Kinmel Bay Coastal Defence Improvement Scheme

Environmental Statement Addendum Non-Technical Summary Final

October 2024

Figure 3-1: Location of new access point in relation to original proposals.

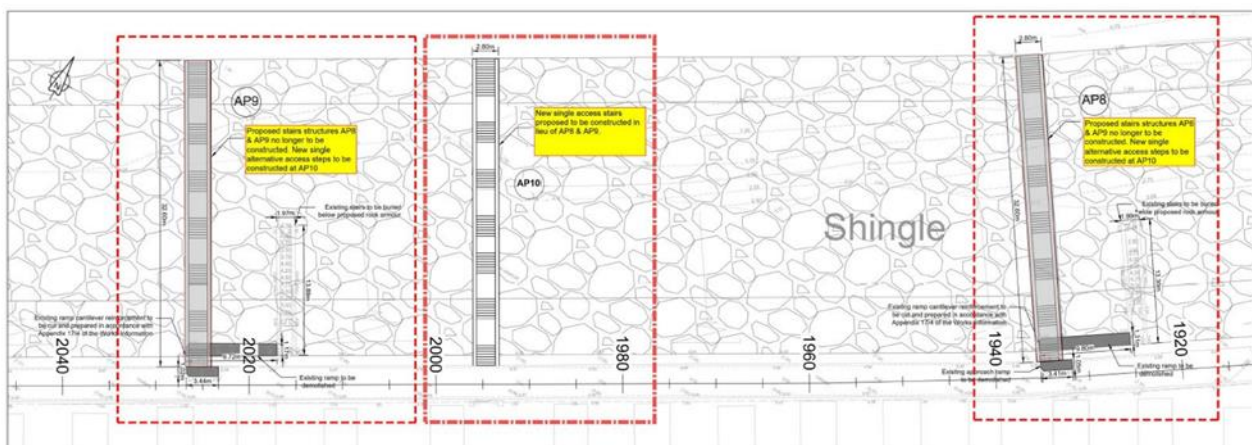
As part of the original application, two access points were proposed in front of Golden Sands Holiday Park. Following further ground investigations and design discussions, two access points (AP8 and AP9) were replaced for a single central access point (AP10), as show on Figure 3-1 below. Originally, both access points in front of the Holiday Park required pilling, and the submitted ES suggested a press-in piling method which minimises noise and vibration created.

However, the press-in piling method requires a large crane to set up the piling rig to lift and position the sheet piles. It was considered too disruptive to the community and close by caravan park to set up a crane in this area.

Figure 3-2: Plan view of proposed cofferdam layout.

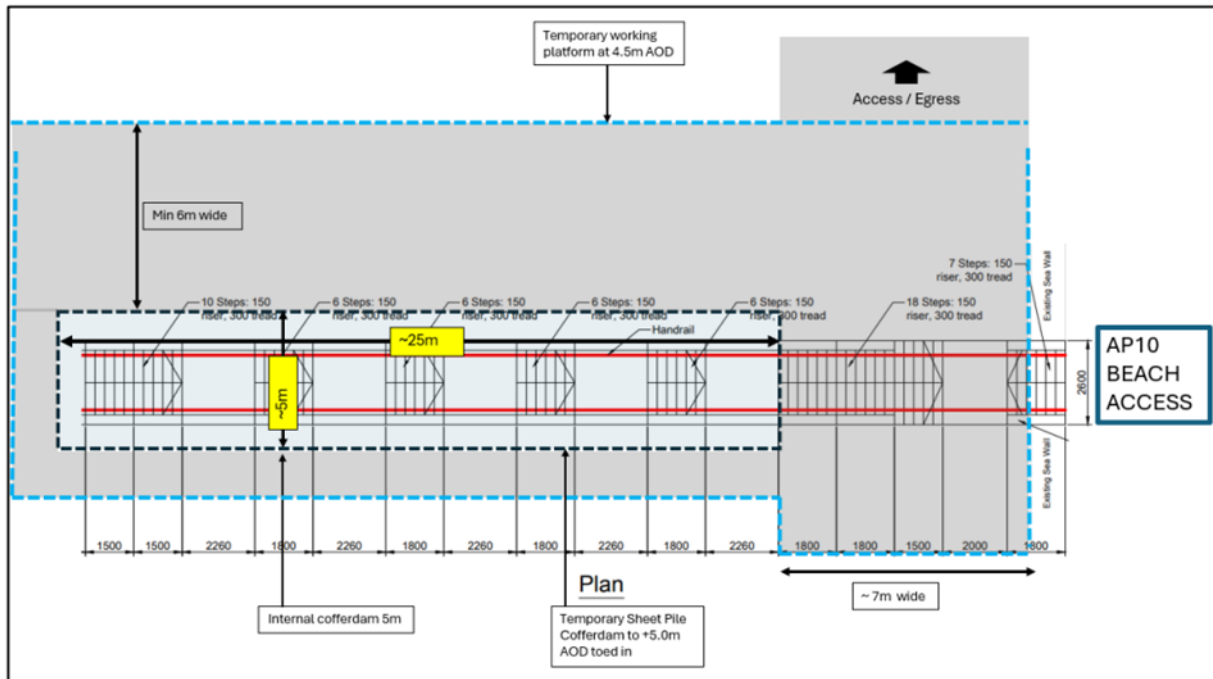
As this new access point (AP10) is located below the Mean High Water Spring, a temporary sheet pile cofferdam is required to provide safe and undisturbed access for construction of the access steps. The cofferdam will involve installing sheet piles around the proposed steps to create a dry working area. This will allow the construction works and material

The temporary sheet piling cofferdam is yet to be fully designed, however, it is expected to be approximately 25m long and 5m wide. The sheet piles will be approximately 12m, with a maximum pile embedment of 9m into the ground.

The temporary sheet piles will be installed with a large, tracked rig using a vibration hammer. The rig will be able to access the working areas along the upper areas of the foreshore without any disruption to the local community and adjacent caravan park. The installation of the sheet piles will be undertaken from above MHWS on a high level temporary working platform adjacent to the existing sea wall.
